BRUNSWICK STEAM ELECTRIC PLANT, UNIT 1 AND 2
NRC DOCKETS 50-325 AND 50-324
OPERATING LICENSES DPR-71 AND DPR-62
REQUEST FOR LICENSE AMENDMENTS
PRESSURE-TEMPERATURE LIMITS CURVES

TYPED TECHNICAL SPECIFICATION AND BASES PAGES - UNIT 2

MARKED-UP TECHNICAL SPECIFICATION AND BASES PAGES - UNIT 1

MARKED-UP TECHNICAL SPECIFICATION AND BASES PAGES - UNIT 2

FIGURE 3.4.6.1-1
PRESSURE-TEMPERATURE LIMITS
REACTOR VESSEL

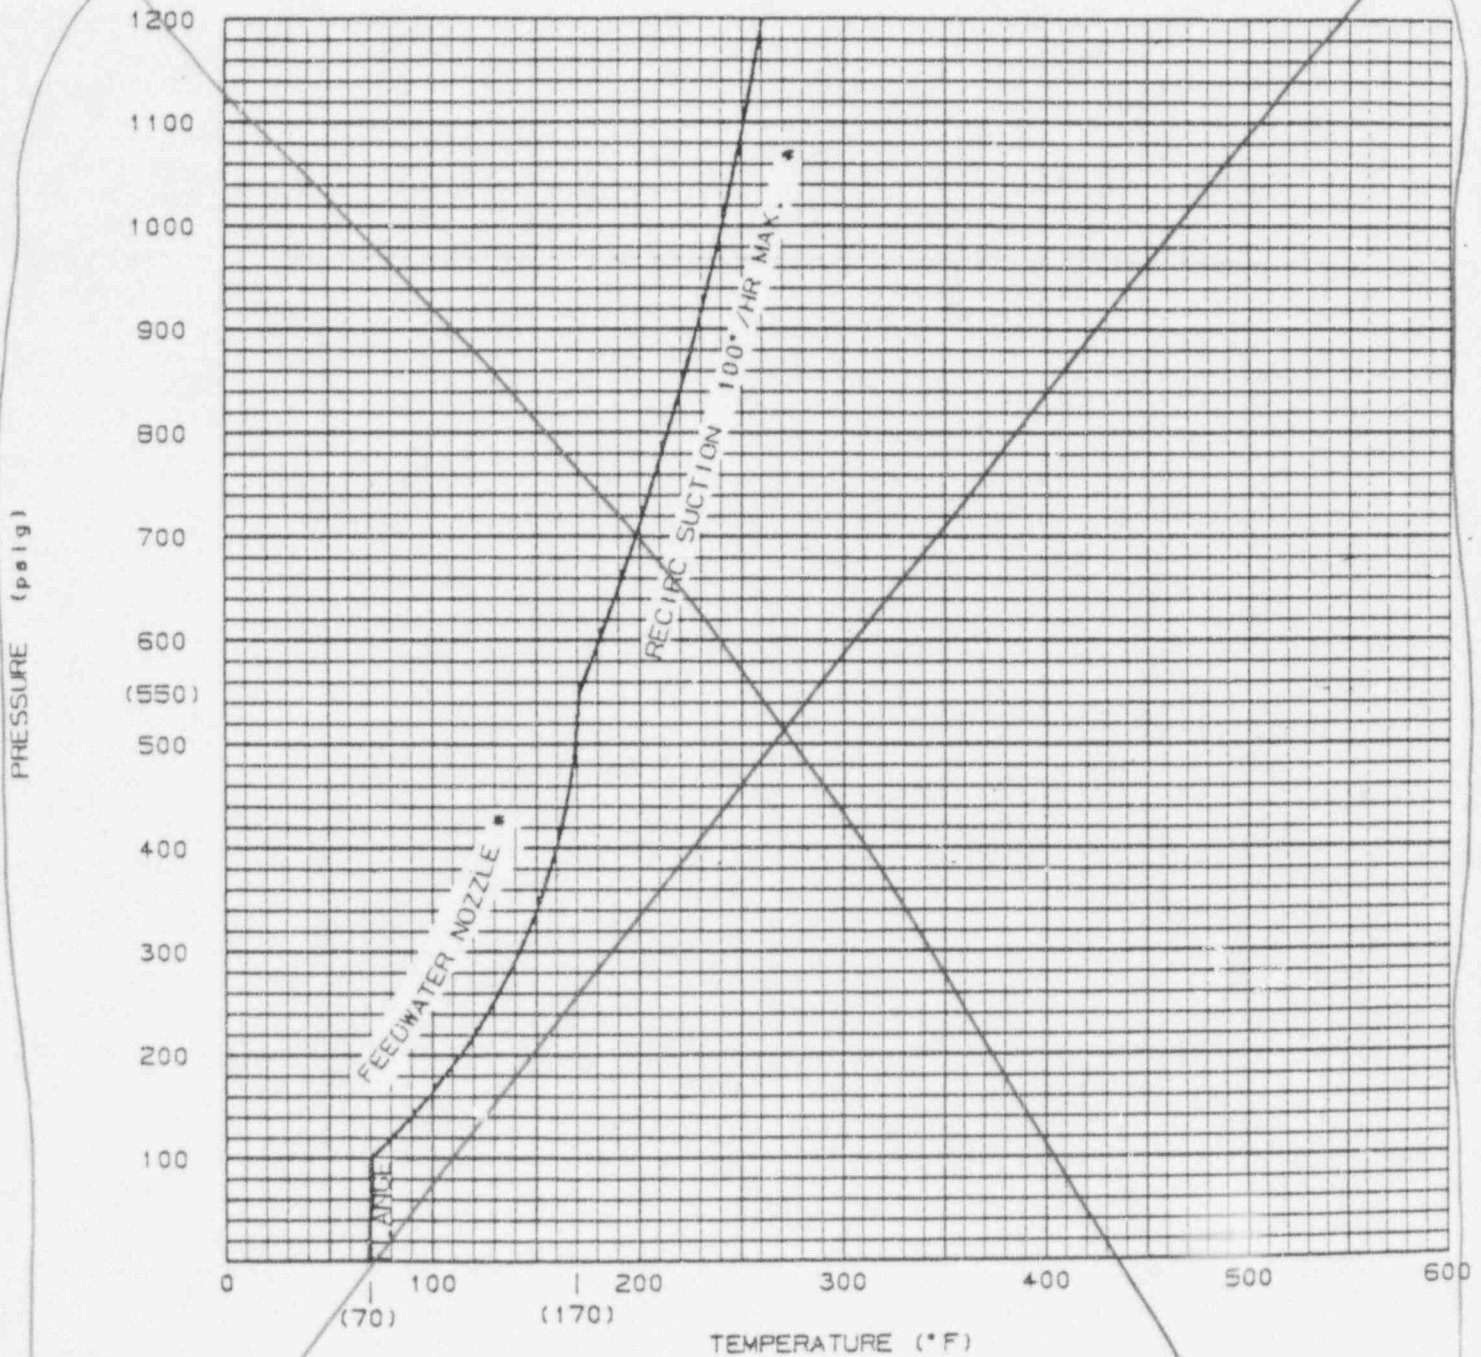
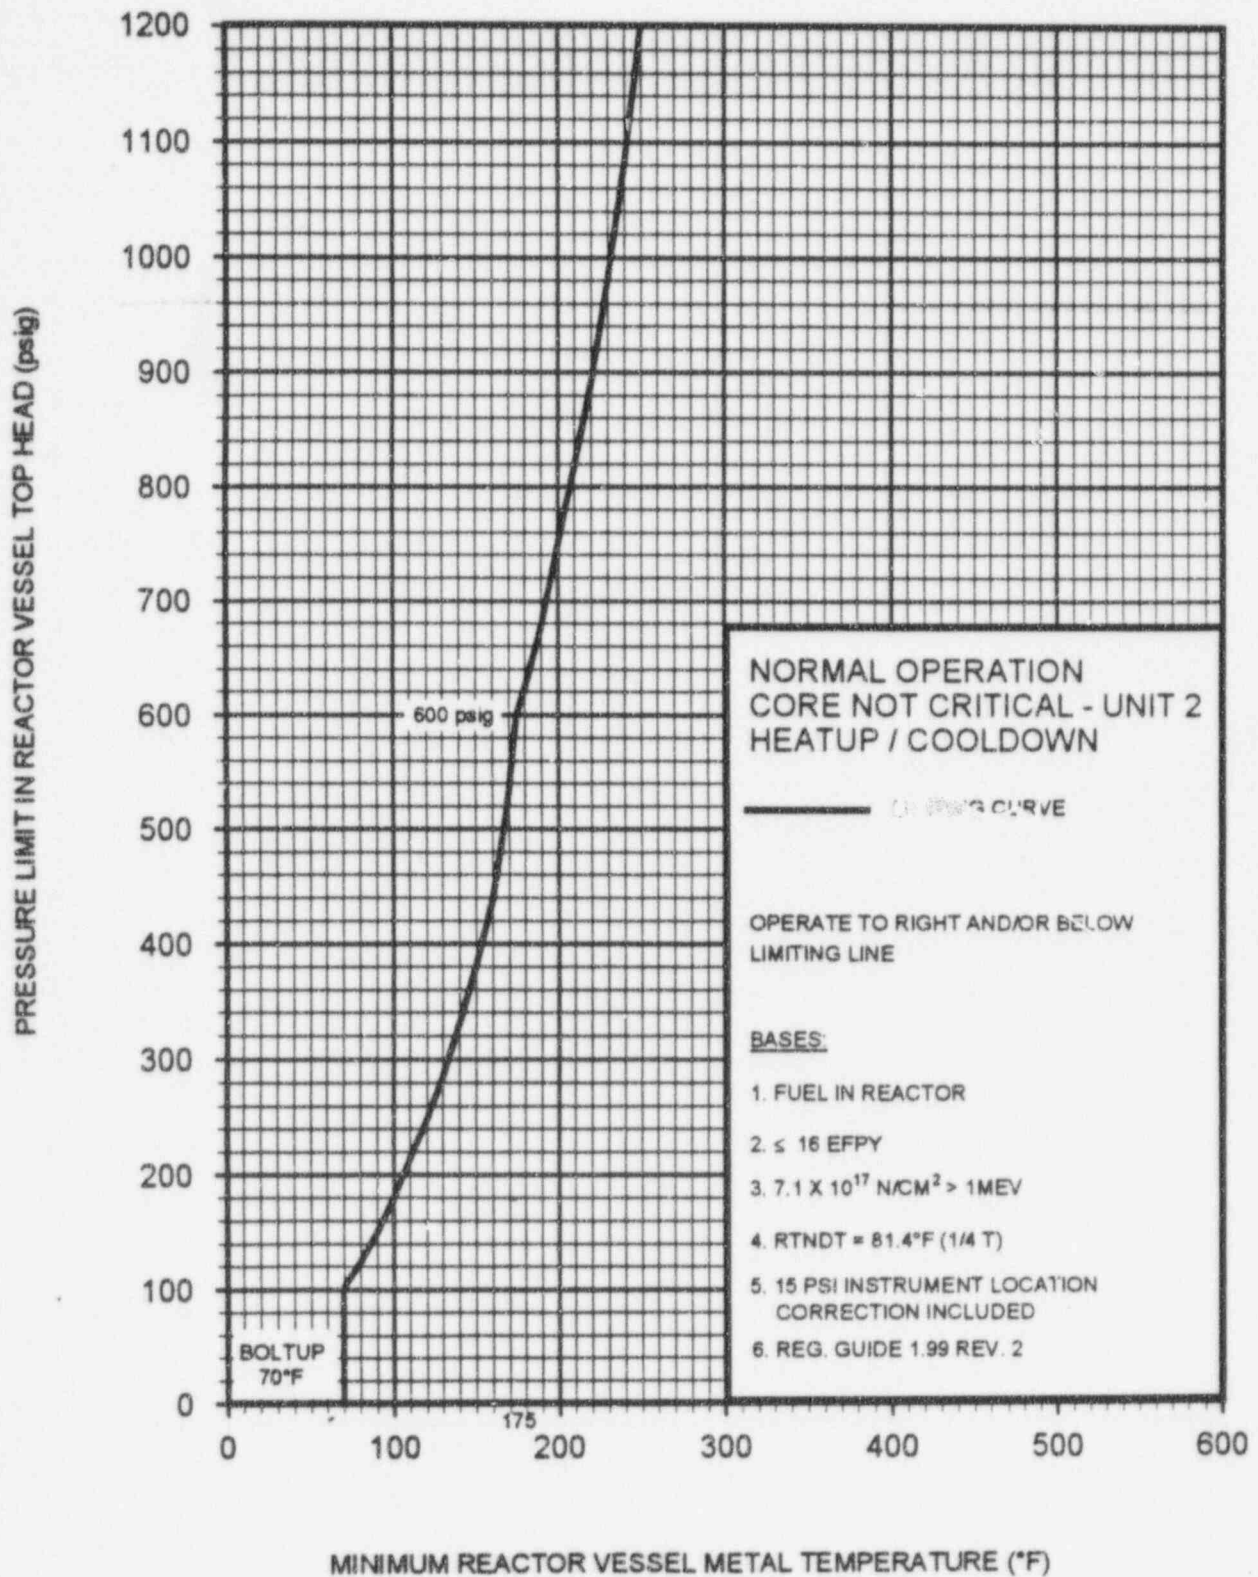
Insert 3.4.6.1-1

Insert 3.4.6.1 - 1

FIGURE 3.4.6.1-2
PRESSURE-TEMPERATURE LIMITS
REACTOR VESSEL

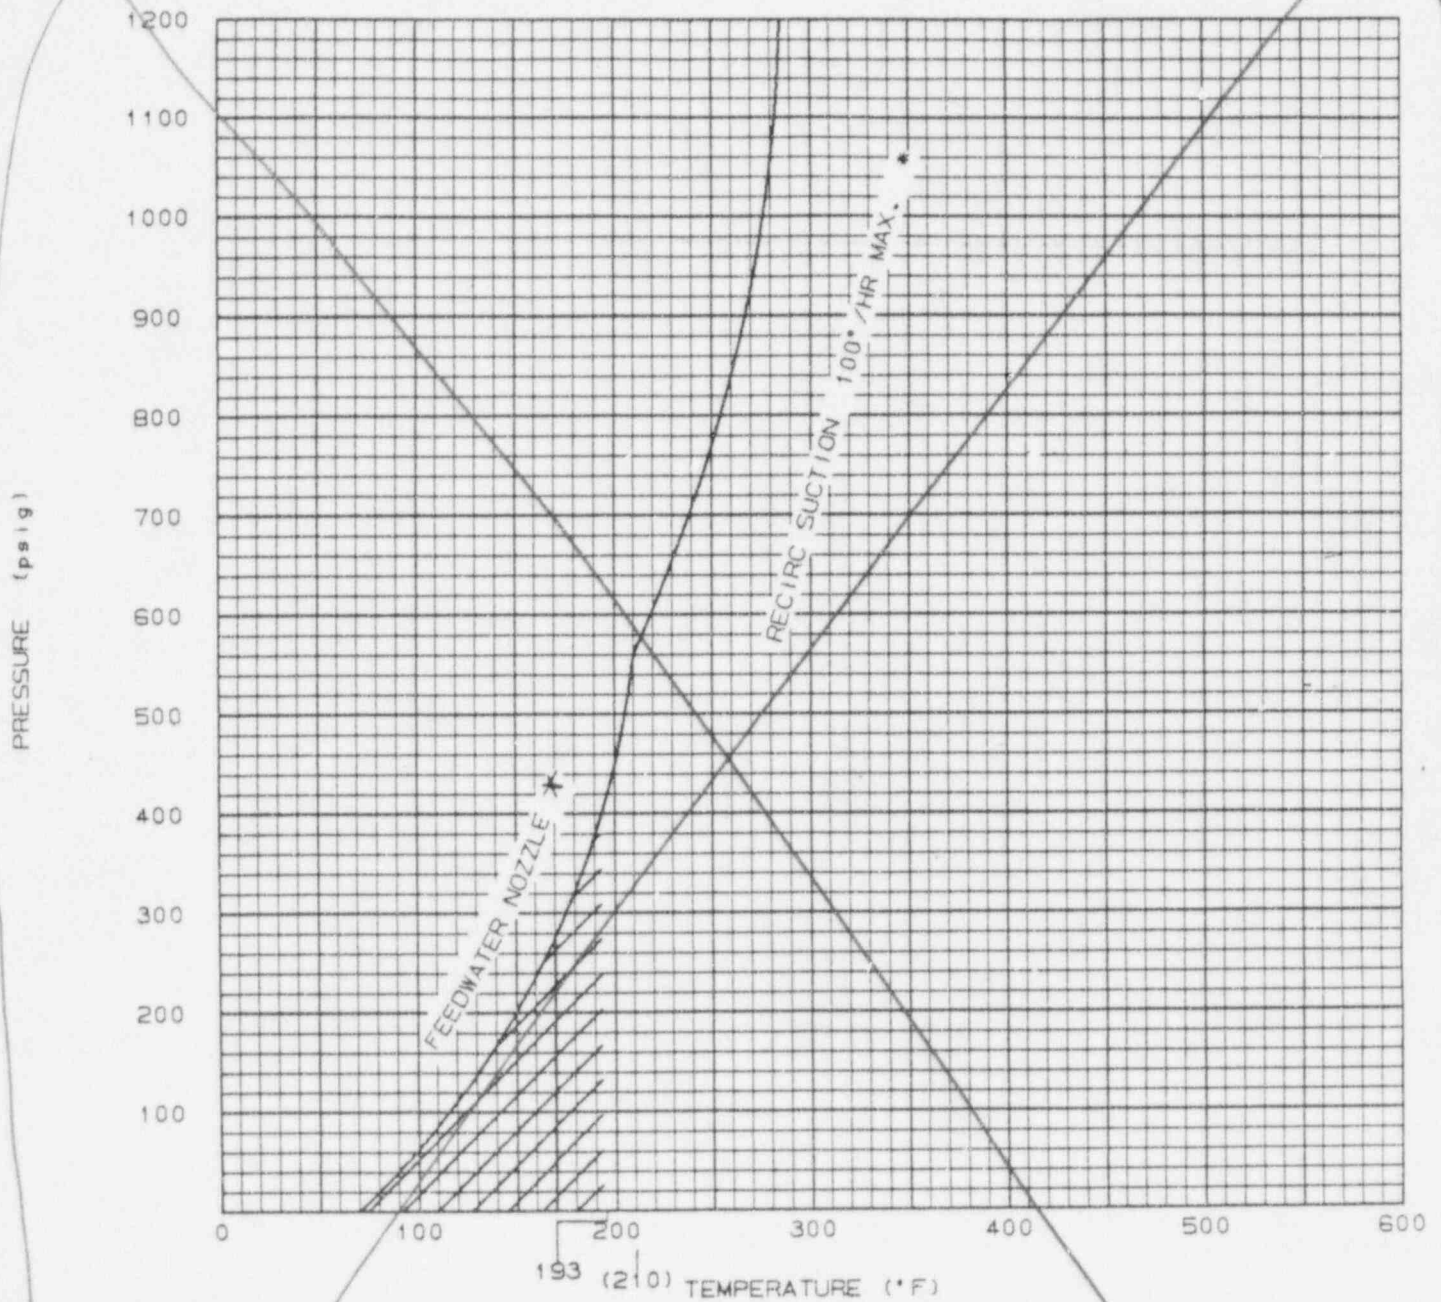
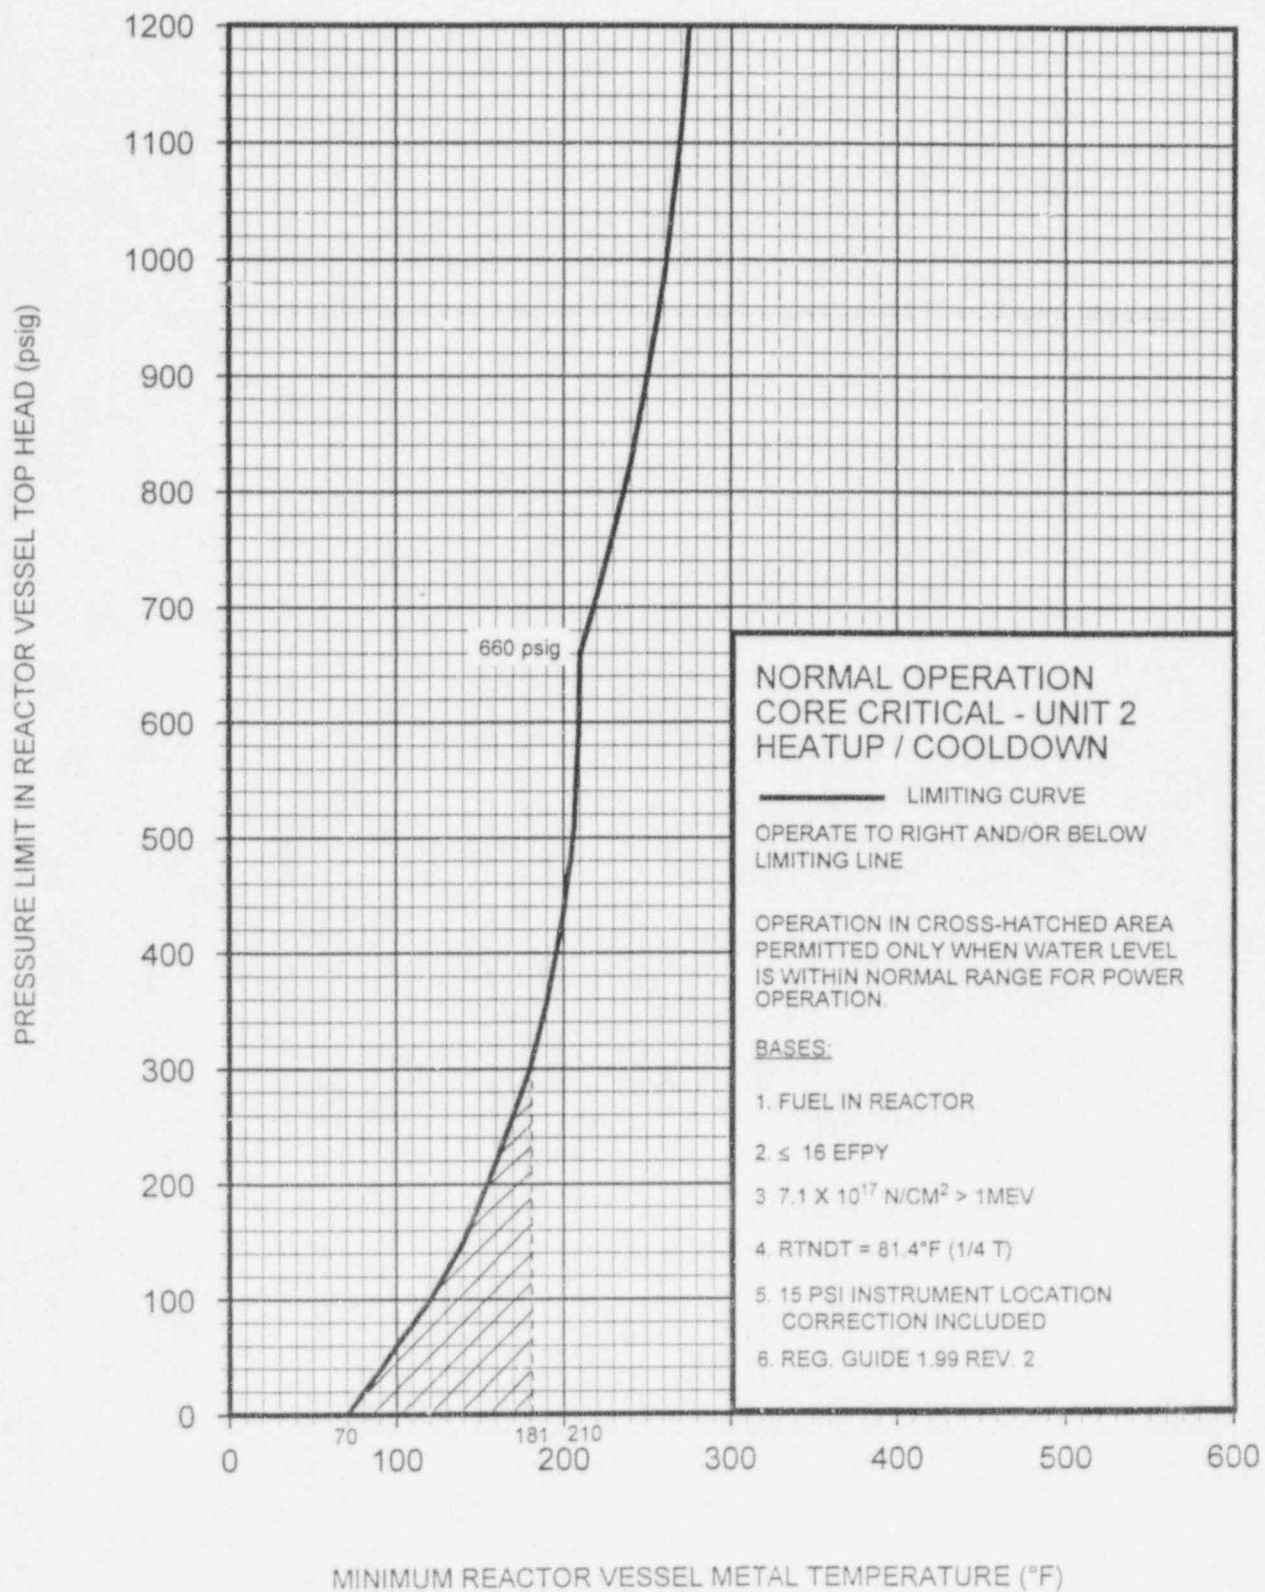
Insert 3.4.6.1-2

Insert 3.4.6.1 - 2

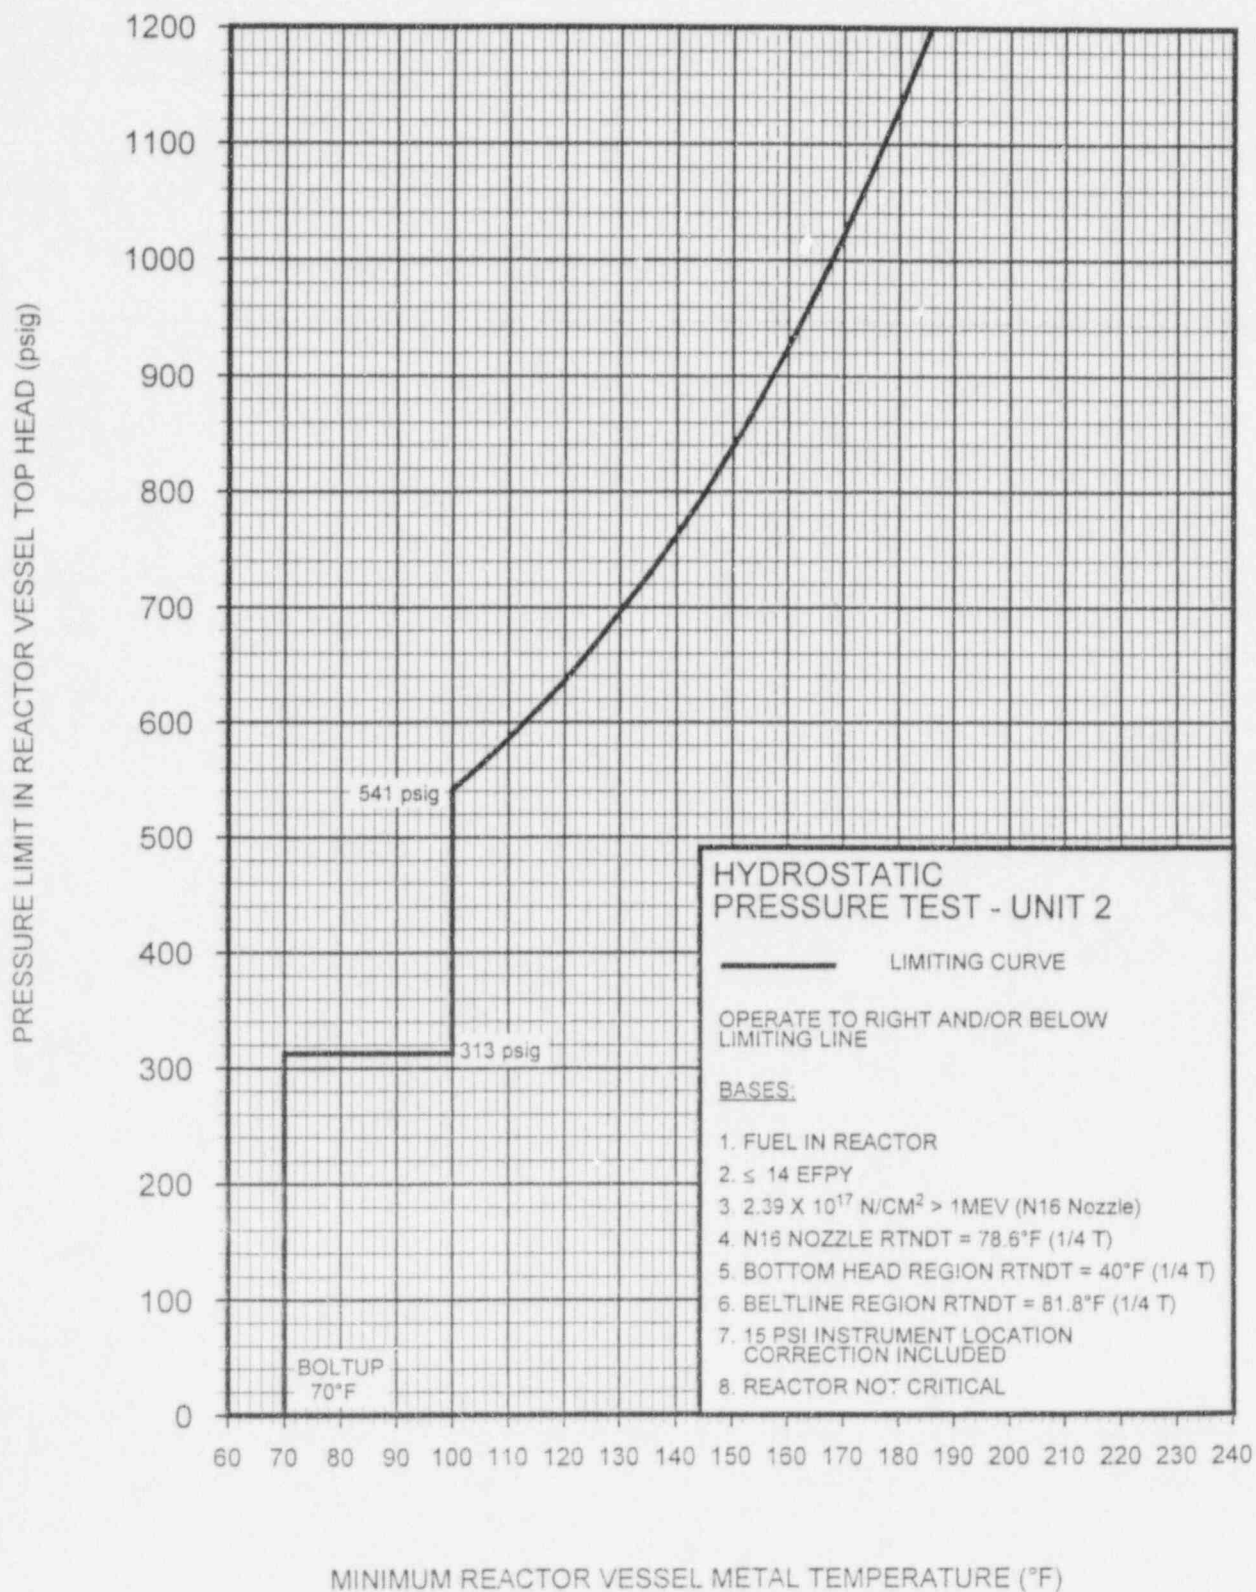
Insert 3.4.6.1-3a

Insert 3.4.6.1 - 3a
